ARCHITECT'S SUPPLEMENTAL INSTRUCTIONS

PROJECT:	Roosevelt Lofts Historic Rehabilitation San Angelo, TX	Report No.	Two (2)
OWNER:	Overland Property Group 234 N. Santa Fe Ave, Suite A Salina, KS 67401	Date	April 29, 2024
CONTRACTOR:	MCP Group 3501 SW Fairlawn Rd. Topeka, KS 66614	Architect's Proj No.	22-3281
		Contract For:	General Construction Mechanical, Electrical

1. Revised Sheets A2.0

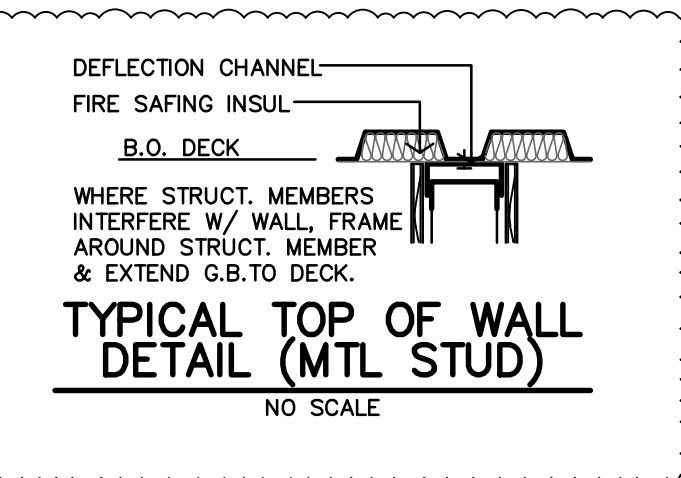
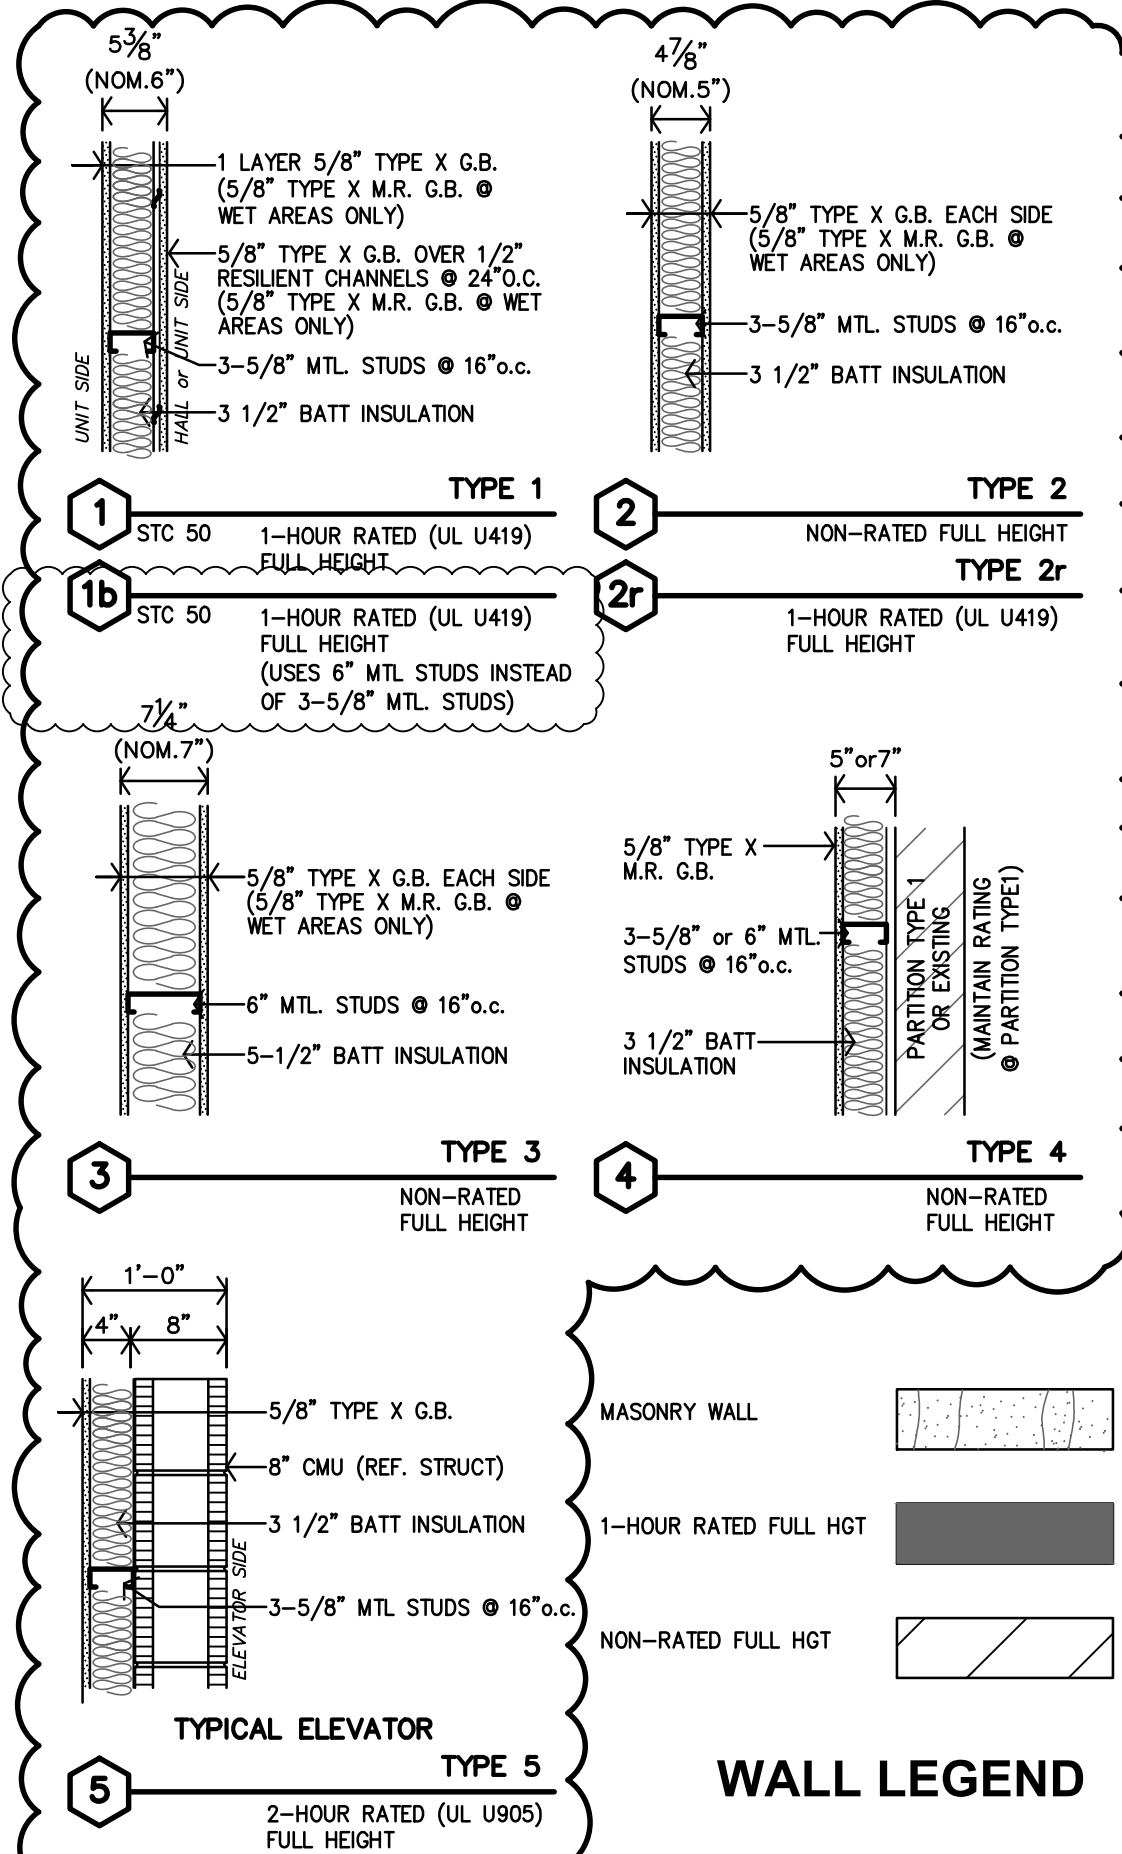
- a. Alternate #3 has been selected and all interior partitions will use metal studs in lieu of wood studs.
 - b. Sheet A2.0, Partition Schedule:
 - i. Partition Type 1 and 1b has been modified to show 3-5/8" (or 6") metal studs with 1 layer of sheet rock on unit side and 1 layer of sheet rock over 1/2" resilient channels on the hall or unit side. This assembly is a UL U419, with an STC rating of 50.

- ii. Partition Type 2 and 2r has been modified to show 3-5/8" metal studs. Type 2r is 1-hour rated and is a UL U419 assembly.
 - iii. Partition Type 3 has been modified to show 6" metal studs.

- iv. Partition Type 4 has been modified to show 3-5/8" (or 6") metal studs.
 - v. Partition Type 5 has been modified to show 3-5/8" metal studs furred out from a 8" CMU system. This assembly is 2-hr rated and is a UL U905 assembly.

- c. Sheet A2.0 – detail A has been modified to show metal studs in lieu of wood studs.
 - d. Sheet A2.0 - Apartment General Notes, Note 6 has been modified to reflect changes to removable cabinet locations in the adaptable units.

- e. Clarification – per addendum #2 – Typical Top of Wall Detail (Metal Stud) was added to the Partition Schedule on Sheet A2.0. This detail was also added to the Partition Schedules on Sheets A2.3, A2.5, A2.6, A2.7 and A2.8.
